Addendum 50 – UN Regulation No. 51

Revision 3 - Amendment 5

Supplement 5 to 03 series of amendments – Date of entry into force: 15 October 2019

Noise of M and N categories of vehicles

"Figure 4c

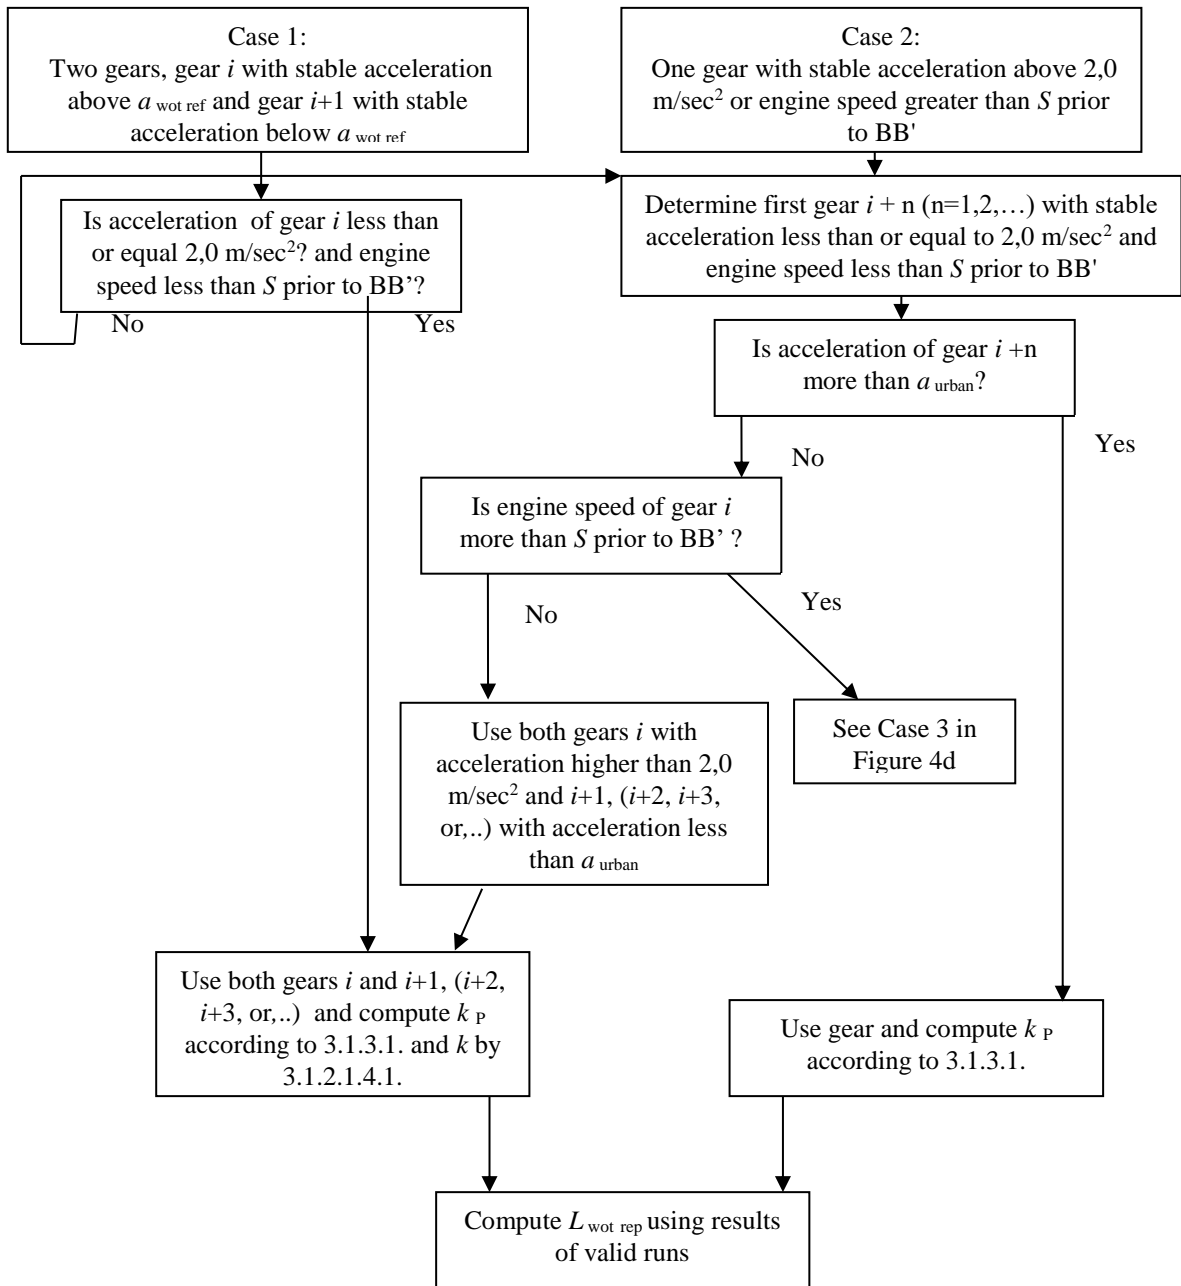
Annex 3, Appendix,

Figure 4c, amend to read:

Flowchart for vehicles tested according to paragraph 3.1.2.1. of Annex 3 to this Regulation
– Gear selection using locked gear PART 2"
